PROJECT
 The Russell Hotel

TITLE
 MEZZANINE FLOOR
 VENTILATION LAYOUT
 SHEET 5 OF 5

P15-260-M57-M1-05 T4
 3

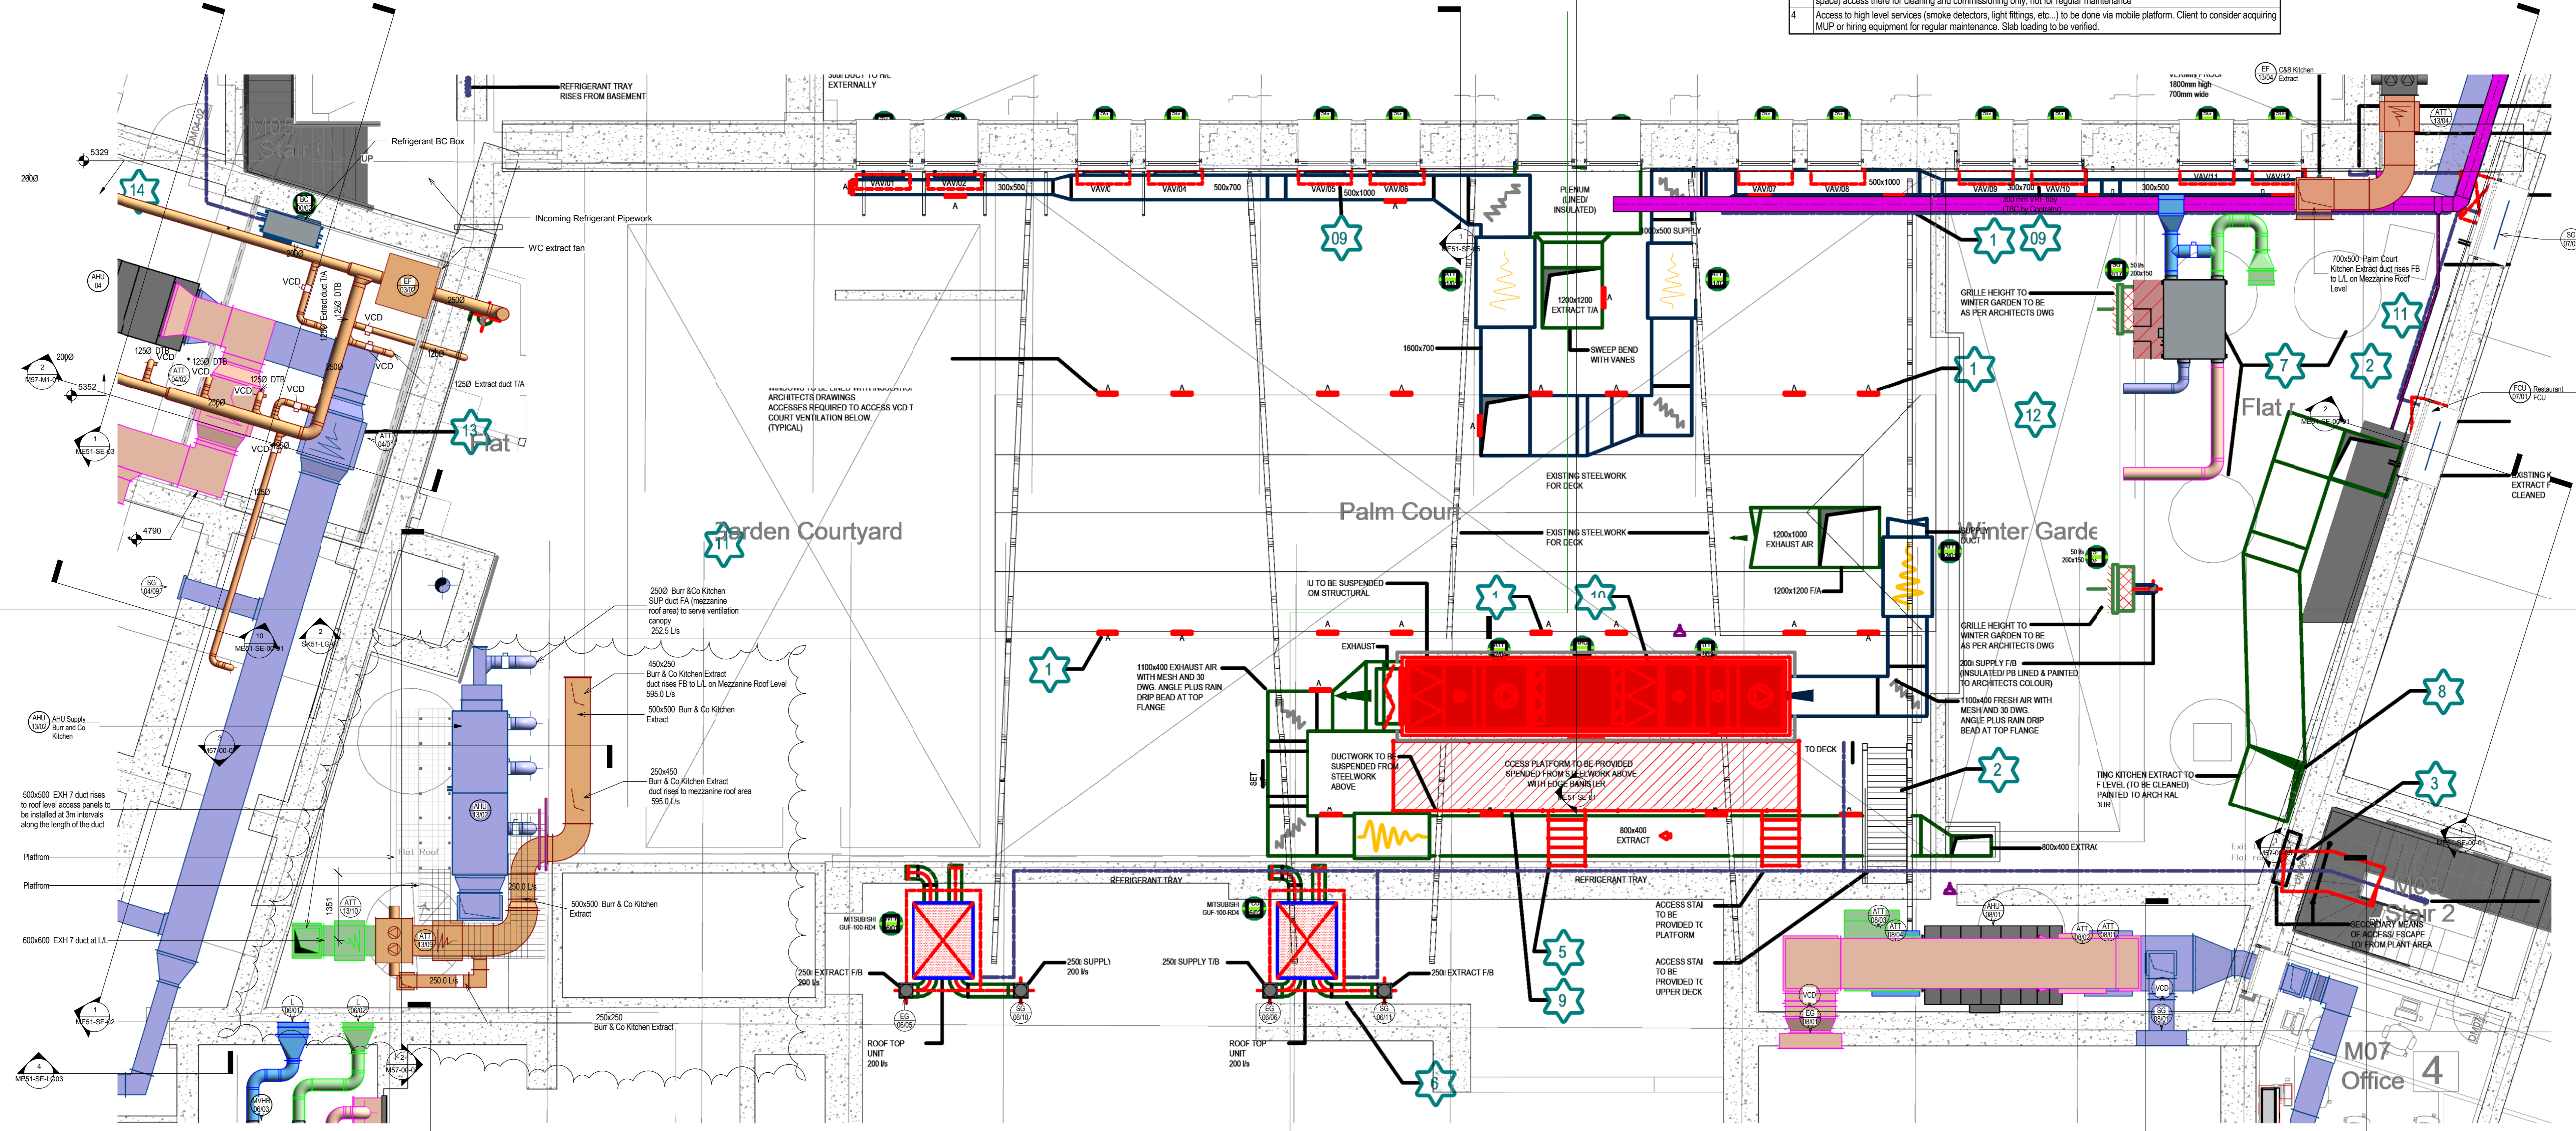
CDM Notes Mezzanine	
Comment Number	Comment Text
1	Regular access to electrically operated dampers and access panels. Access is via lead roof. Structural adequacy of this means of access to be reviewed by structural engineer / CDM coordinator.
2	Stairs to be provided for means of plant access and escape. Steep stair for plant access with banister to be detailed by architect.
3	Access to roof restricted. Existing roof has limited load bearing capacity to be confirmed by structural engineer.
4	Secondary means of access and escape from roof.
5	Access route for plant, equipment, tools, hoists & material. Contractor to install temporary rail or beam system with external scaffolding to permit transport of goods through passageway. Please refer to 'CDM' note on Balcony. Contractor to provide method statement. Existing plant to be removed prior to working taking place (kitchen ventilation).
6	Means of access to the roof above lobby.

7	Access to roof level shall be strictly controlled. There is no edge protection. Equipment to be located >1m away from edge. CDM issues to be reviewed.
8	Structural integrity of existing old roof light mills to be verified.
9	Vertical ductwork cleaning is via abseiling. Architect/ contractor to provide access & assailing secure points at roof level (applies to 4m ducts in 3 distinct locations in courtyard).
10	Access platform for ahu to be provided by architect/ structural engineer/ contractor for plant maintenance (Suspended from steels above).
11	New 'AHU 02' to be underslung to existing structural beams. Capacity & detailing by structural engineer.
12	Structural loading capacity. When storing plants equipment or hoists & machinery, check slab structural loading capacity - provide temporary propping at ground floor below (and basement) as required.
13	Glass roof to be protected during works.

14	Contractor to provide metal plate and steps to access over duct. Egress below high level extract duct is restricted (crawl space) access there for cleaning and commissioning only, not for regular maintenance.
4	Access to high level services (smoke detectors, light fittings, etc.) to be done via mobile platform. Client to consider acquiring MUP or hiring equipment for regular maintenance. Slab loading to be verified.
